IMPORTANT SAFETY RECALL  
NHTSA RECALL #13V-620

PREVOST SAFETY RECALL CAMPAIGN SR13-93 "Seat Belt may be Difficult to  
Unlatch/FMVSS 209"

**SR13-93**

DATE :	JANUARY 2014	SECTION :	18 - Body
SUBJECT:	IMMI Seat Belt may be difficult to unlatch

Image: IMMI

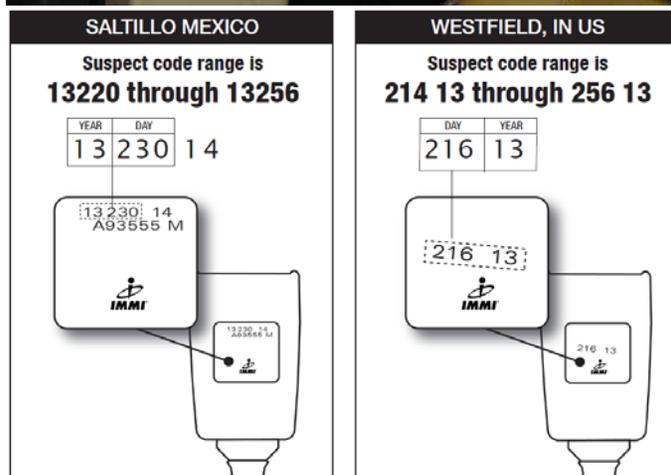
Locate the side-wall mounted retractable shoulder belts in the vehicle.  
Check the date code on the other side of the buckle.

ON POST BETWEEN WINDOWS, ROAD SIDE AND CURB SIDE, CHECK DATE CODE ON OTHER SIDE OF BUCKLE.

Two suspect date code ranges are involved:

**13220 through 13256**

AND

**214 13 through 256 13.**

If the buckle date code is within either of the ranges above, replace the part.

Select the retractable shoulder belt in assembly #864813.

Install on wall.

Torque belt anchor to 27 lbf-ft

*If the date code does NOT fall within either range, do NOT replace the part.*
